# CITY PLANNING COMMISSION

**APPLICATION:** Special Permit to construct a 2,118+ square foot Long John Silvers Restaurant with a drive-up service window.

**LOCATION:** Southeast corner of Northgate Boulevard and Winterhaven Avenue

PROJECT EVALUATION: Staff has the following comments:

**EXHIBIT A  
SITE PLAN**

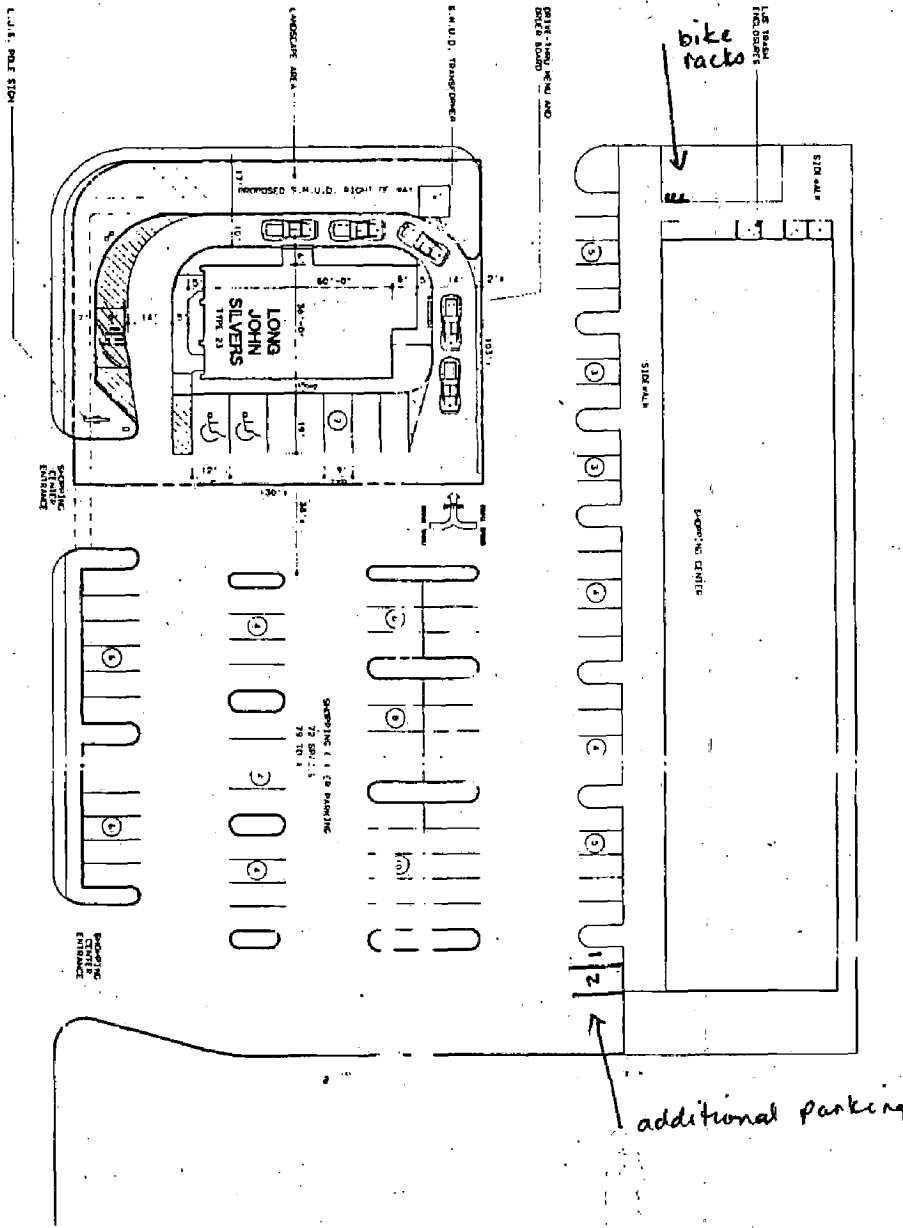
The drive-up lane is not in compliance with the proposed ordinance condition for minimum vehicle stacking space for a facility with a separate ordering board and pick-up window. Although the drive through lane is approximately 240 feet in length, the pick-up window is located half way between the entrance and exit of the lane, thus reducing the effective stacking area to 120 feet. There is stacking area for three vehicles to the ordering board and three vehicles to the pick-up window.

The shopping center presently has 73 parking spaces. The site plan for Long John Silver's depicts seven parking stalls and one parallel stall. The City does not permit parallel parking stalls, therefore, the total proposed parking for the site is 80 parking stalls. The combined parking required for the shopping center and Long John Silvers is 82 parking spaces.

The two additional parking spaces can be provided at the southeastern corner of the parking area if the existing bike racks are relocated to the northeastern corner of the site, as shown on Exhibit A. The other alternative is that the applicant reduce the capacity of the restaurant by six seats. Staff is not supportive of a variance from the required parking as there is no circumstances unique to this proposal that would justify the granting of a variance and thus, granting of a variance in this situation would be a grant of special privilege.

1. The applicant shall submit a landscape plan for staff review and approval prior to issuance of building permits. Provide interior landscaping and screen the SMUD transformer.
2. The applicant shall record the lot line merger for the site prior to issuance of building permits.
3. All trash enclosures shall be designed to City standards.
4. The applicant shall provide additional parking spaces and relocate the bike racks, as shown on Exhibit A or reduce seating for the restaurant by six seats, for a total capacity of 78 seats.
5. A signage program shall be submitted for review and approval of staff prior to issuance of sign permits. Detached signage shall be monument type and shall not exceed 12 feet in height measured from the top of the sidewalk.

additional parking

**EXHIBIT C**  
**ELEVATIONS**  
 P88-152

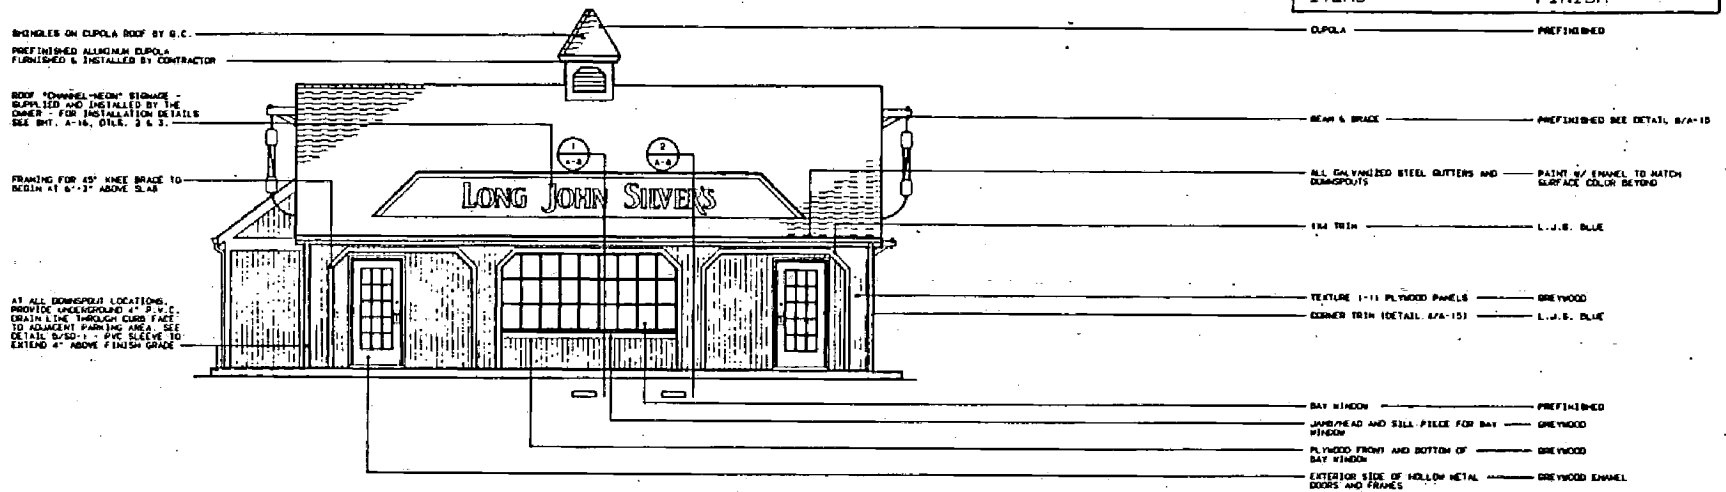
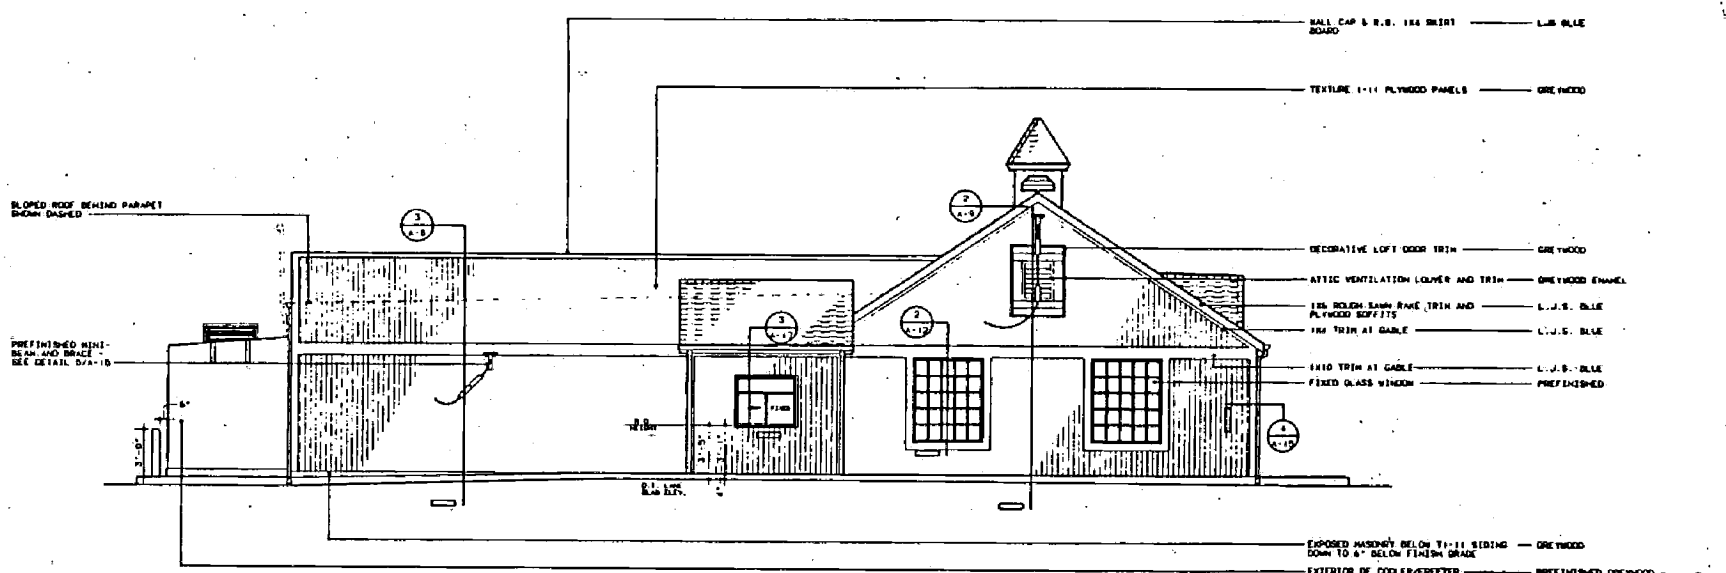
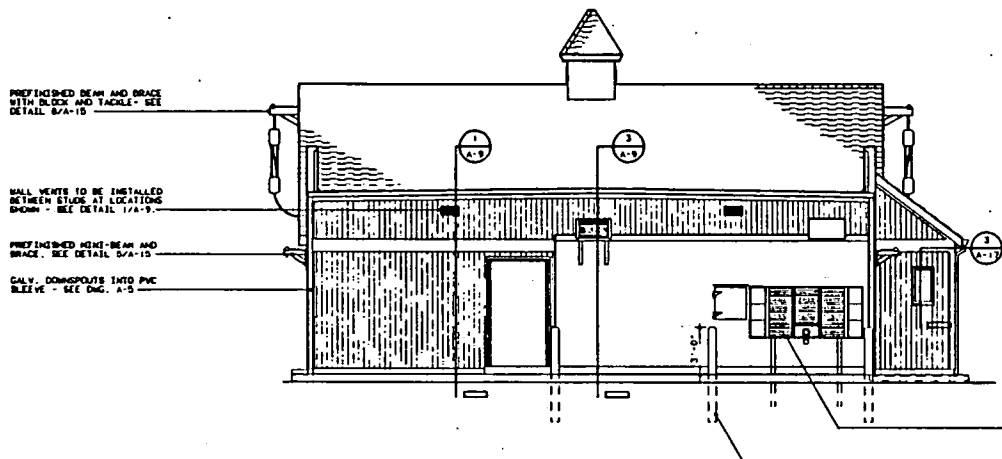
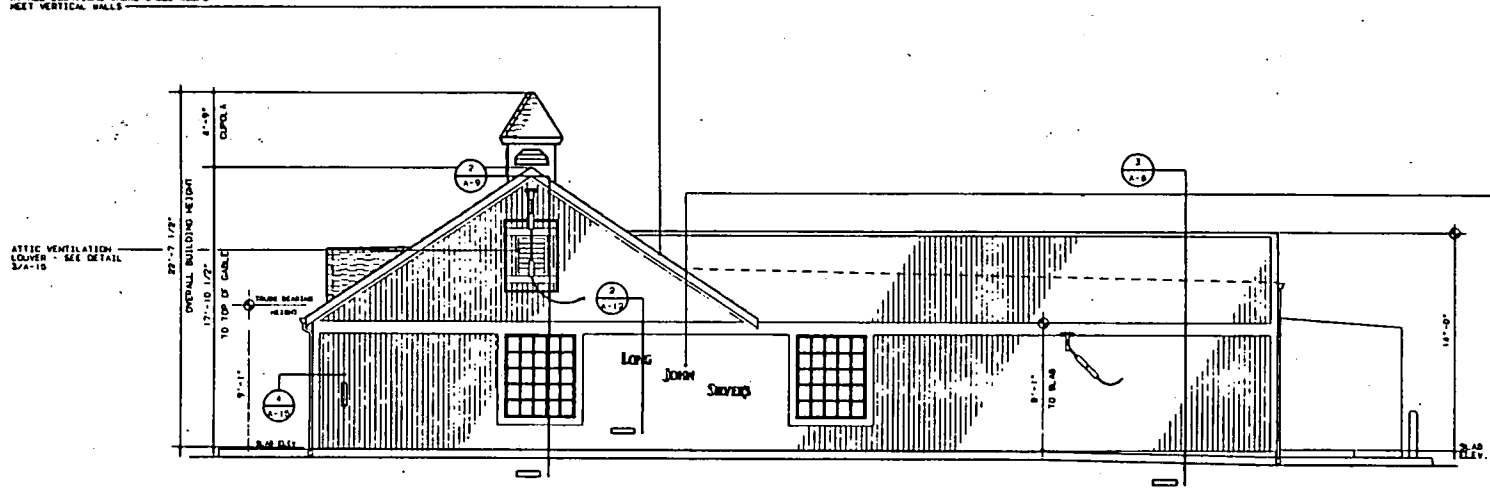
The Sign Ordinance permits one detached sign for each parcel at one square foot per lineal foot of frontage in the C-2 zone. Parcels with frontage on more than one street are permitted one sign for each street frontage. The shopping center has an existing monument sign fronting on Northgate Boulevard. The applicant could add their name to this sign. A detached sign is also permitted on Winterhaven Avenue. Staff recommends that this sign be a monument sign with a maximum height of 12 feet that shall be compatible with the existing monument sign on the site. The applicant has noted that they intend to install a pole sign, however, no sign elevations for a pole sign were included with the submitted site elevations.

The Sign Ordinance also permits two attached signs for each occupancy at three square feet per front foot of occupancy. The signs depicted on the submitted elevations are in compliance with the requirements.
